Application reference: EPR/YP3236RW/V006

Operator: Duranta Teesside Limited

Facility: Teesside AD Power Plant EPR/YP3236RW, Forty Foot Road, Middlesbrough, TS2 1HG

This document has been prepared in response to a request for information received by the Environment Agency with respect to the above application on 4.8.26.

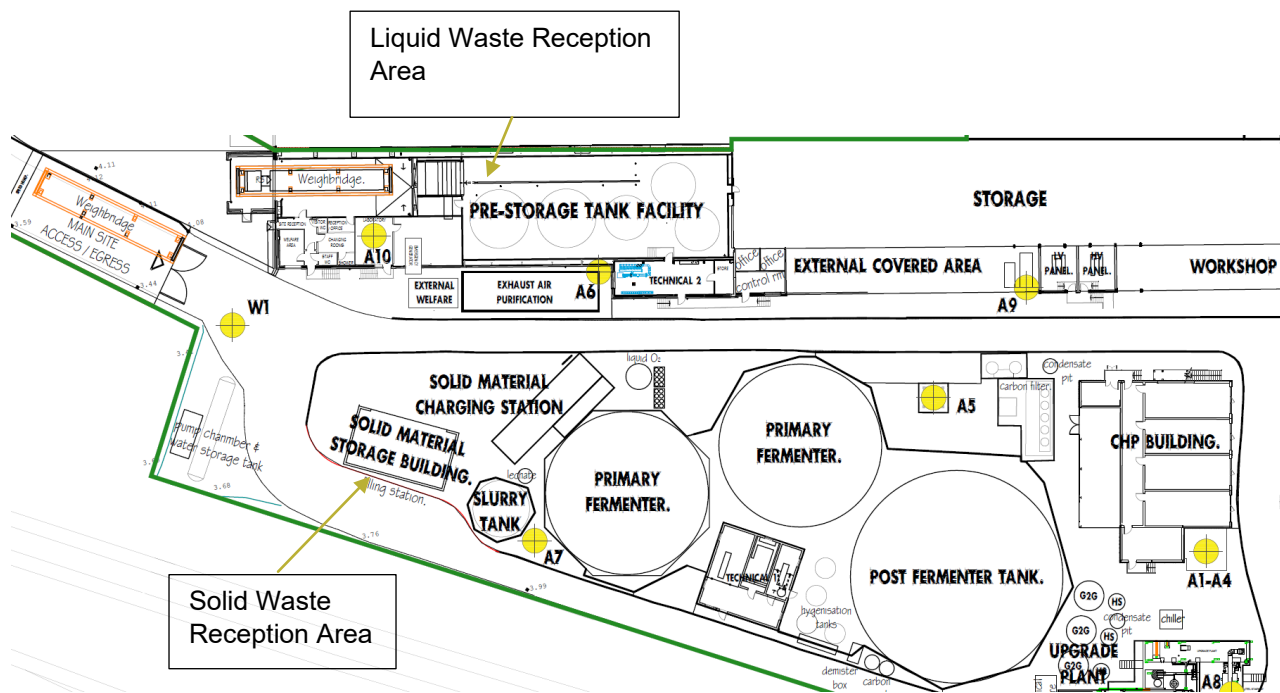
For the new EWC codes, clearly explain how and where these will be accepted on site.

These wastes will be accepted according to the existing procedures and using the existing facilities for receipt of solid and liquid wastes. A summary of the location and nature of waste reception facilities at the site is as follows.

1. For receipt of wastes in solid form – wastes are received in the solid material storage building inside an enclosed building.
2. For liquid waste, tankers offload inside the sludge reception hall and pump into the pre-storage tanks.

A screen shot of these areas as shown on the site emissions points and layout plan is shown below

Both reception areas are enclosed inside a building with an impermeable surface and sealed drainage system, and odorous air from both areas is collected and channeled to an odour abatement system prior to release. Further details of the abatement systems are provided in the Odour Management Plan submitted with this application, and remain fit for purpose and unchanged as a result of this application.

Duranta Teesside Limited
Flare Usage Process Flow
August 2026

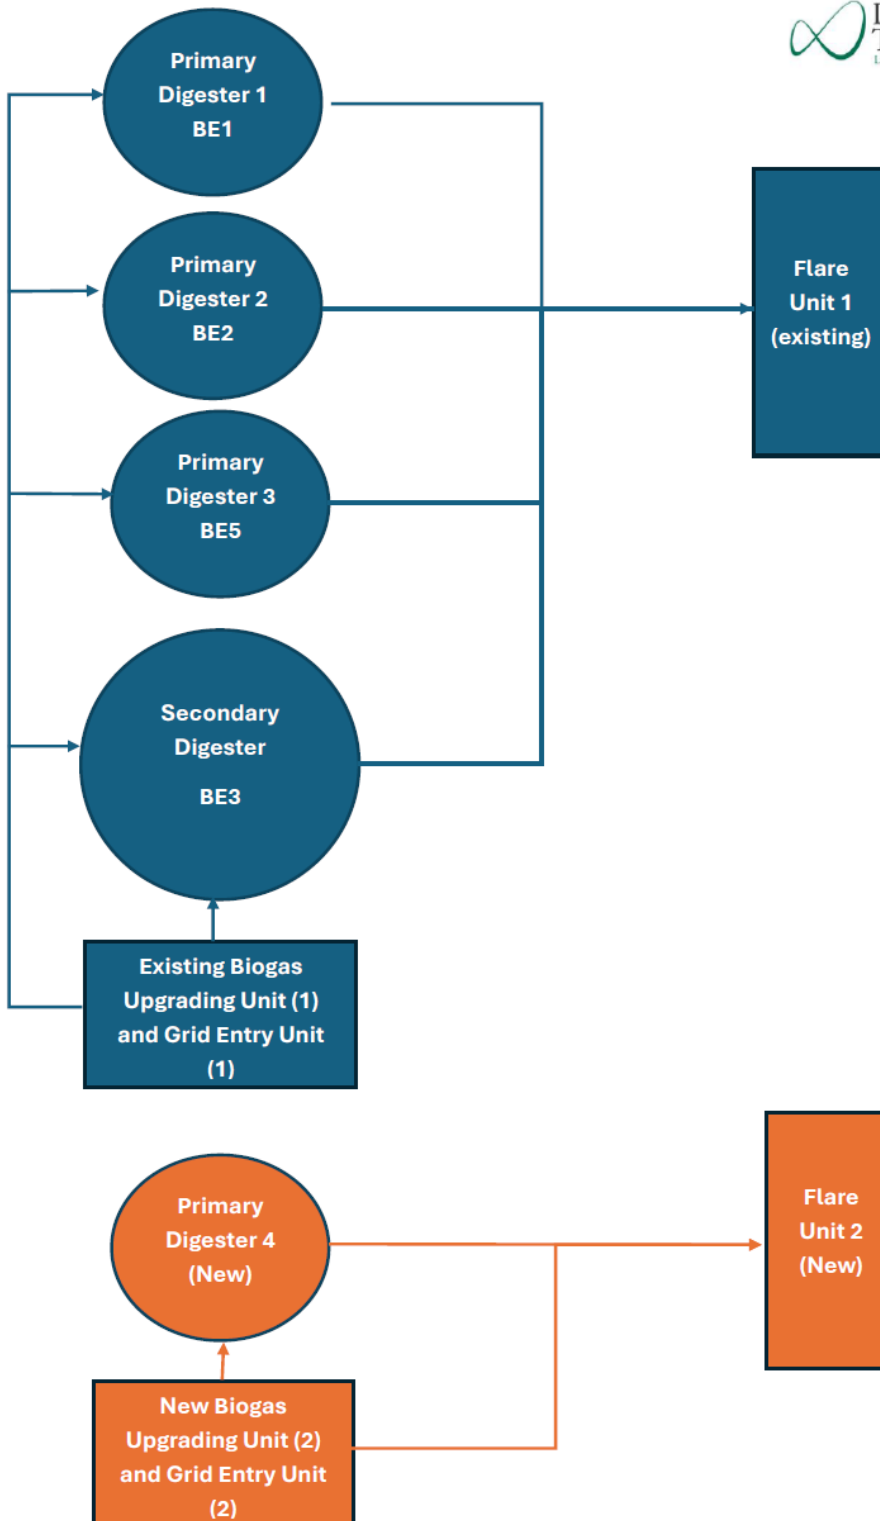
On review of your proposal, it is unclear what assets the new flare will serve. i.e. if this is just the new biogas upgrading plant. Provide a clear process flow diagram that identifies the assets that the new and existing flares will serve as your waste gas inventory identifies that “off-spec biogas” will be burnt in the emergency flares. “BAT is to use flaring only for safety reasons or for non-routine operating conditions (e.g. start-ups, shutdowns)” the flaring of “off-spec biogas” would not be considered BAT unless this was as part of the limited shutdown or diversion switchover.

Clearly explain the situations that off-spec biogas will be flared, and how this will meet BAT.

The existing emergency flare serves the existing plant which includes all gas (in storage, transport and use) arising from existing operations. This includes gas from the existing biogas upgrading unit. Biogas from the existing biogas upgrading unit and grid entry unit is returned to store in the secondary digester and gas stored in the secondary digester can be routed to flare in emergency/abnormal operational conditions.

The new flare will exclusively serve the new development area, so gas associated with the new digester, biogas upgrading unit and associated grid entry unit.

The wastewater and waste gas streams inventory submitted identifies 'off spec biogas from the upgrading process' as a potential waste gas stream arising from operations. The document states that this waste gas stream will be either burnt in the emergency flare but also states that it may be returned to gas storage.

A simplified process flow diagram on the next page of this document shows this arrangement.

Under normal operating conditions, reject gas from the biogas upgrader and Grid Entry Unit (GEU) is returned to the enclosed gas storage bag in the head of the digesters. The GEU has provision for propane injection into the biomethane to meet the required gas quality specification for grid injection. The propane enrichment system is automatically stopped if the required gas quality is not achieved within 20 minutes, with manual intervention then required to identify and rectify any fault.

The reject gas is returned to the digester gas storage bag, where it is diluted within the existing biogas volume and does not present an operational issue under normal conditions.

However, under an abnormal condition, such as a failure of the propane control system, continuous enrichment or excessive propane dosing could occur, resulting in elevated propane concentrations being returned to the digester gas space. This could subsequently cause gas quality and operational issues for the downstream membrane treatment system.

Only under such abnormal conditions would the reject gas be diverted to the flare for controlled disposal. Under normal operating conditions, off spec or reject gas from the upgrader and GEU is not routed to the flare. As such the operator can demonstrate that the current and proposed flare operations at the site are in accordance with BAT. Flare usage can be demonstrated to have been designed to minimise operation and ensure use only for emergencies, during maintenance, and during unusual operational conditions to protect the integrity of the plant.
